FINAL

**Globemaster Corridor Specific Plan
Program EIR/EIS (SCH No. 2018091021)
EIR-03-17**

FIGURE 3.13-1

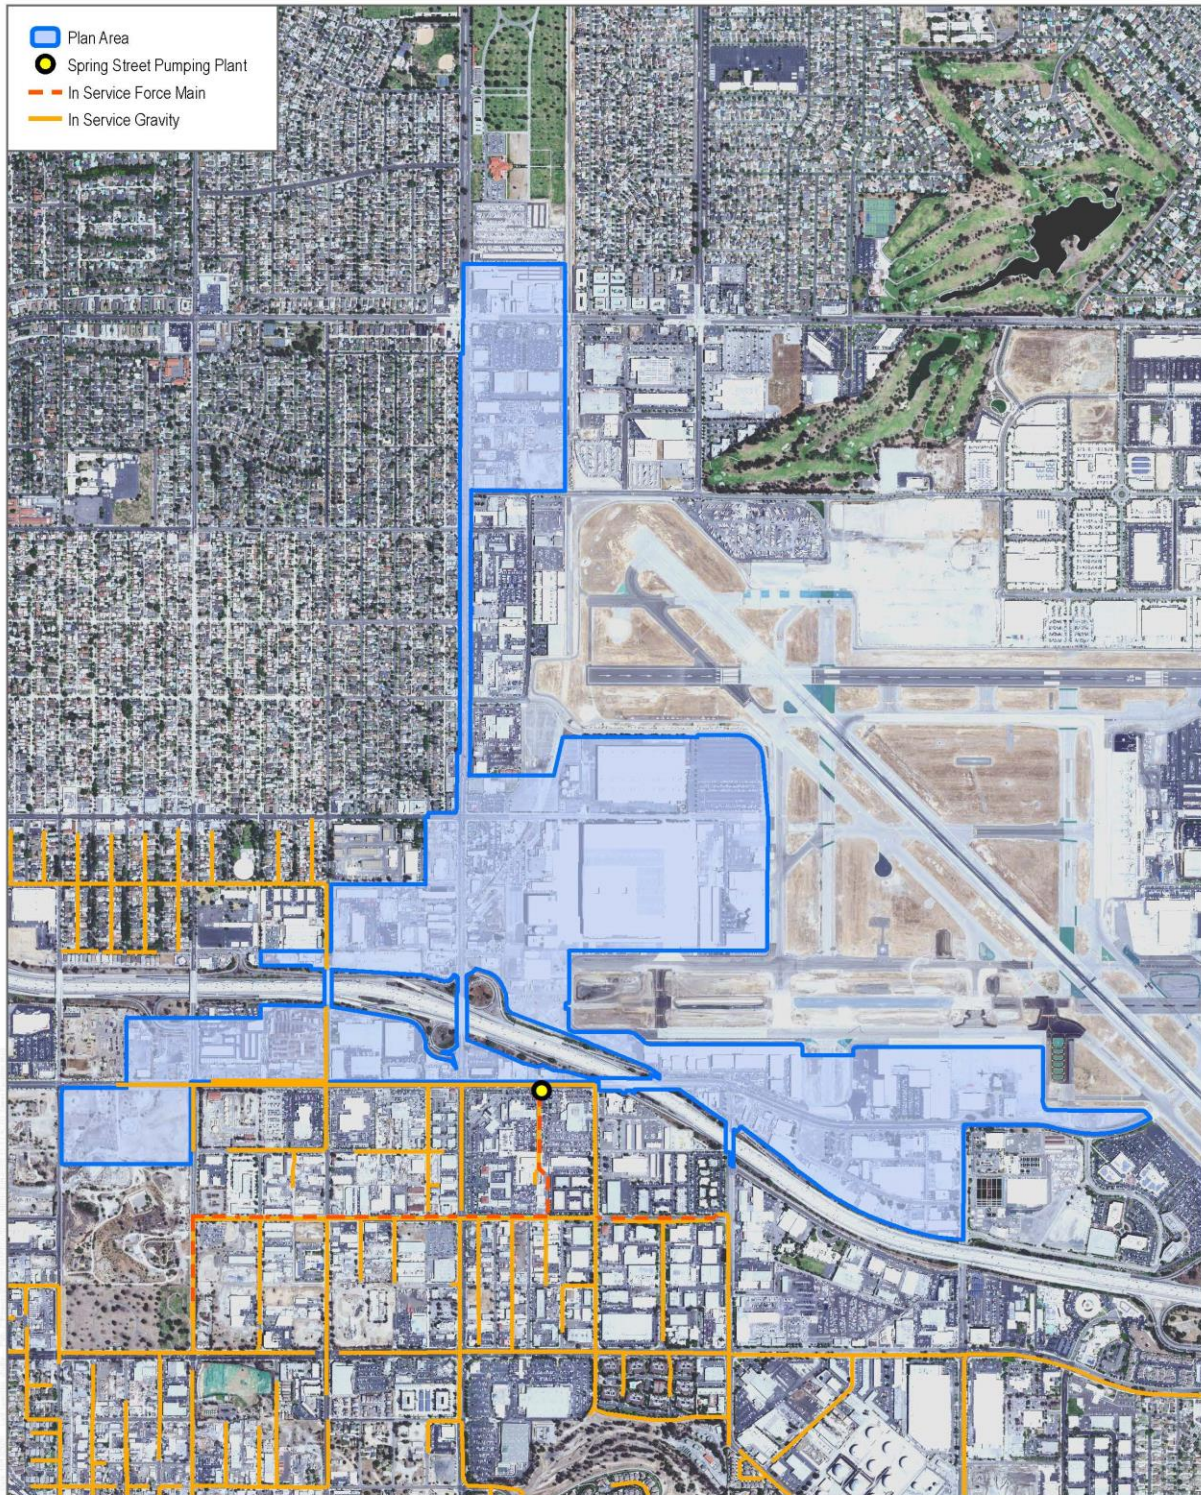
7-4 The commenter raises issue with Section 3.13.1, Existing Conditions, in Section 3.13, Utilities and Service Systems, of the Draft PEIR/PEIS because it does not provide a detailed discussion on how wastewater is conveyed from the Plan Area to the LACSD trunk mains. As provided in Chapter 3, Changes to the Draft PEIR/PEIS, of this Final PEIR/PEIS, this section has been revised to include a more thorough discussion of LACSD's trunk lines within the Plan Area. In addition, a new figure (Figure 3.13-1, LACSD Sewer Lines) is provided in this Final PEIR/PEIS. Additionally, Chapter 3 of this Final PEIR/PEIS notes that sewer lines within the Plan Area would generally flow south toward Spring Street and then east toward the Spring Street Pumping Plant. Given the programmatic nature of the analysis, the existing conditions did not describe each existing lateral and local connections from within the Plan Area towards the LACSD facilities. Additionally, MM-UTIL-1 requires project-specific analysis that would describe the existing sewer facilities operated by LBWD and their flows towards LACSD trunk mains.

Figure 3.13-1, LACSD Sewer Facilities, has been added based on a comment provided from the Long Beach Water Department to include a more thorough discussion of LACSD's trunk lines within the Plan Area. See the revised figure attached to the end of this chapter of the Final PEIR/PEIS. The proposed revision does not alter the analysis or conclusions presented in the Draft PEIR/PEIS.
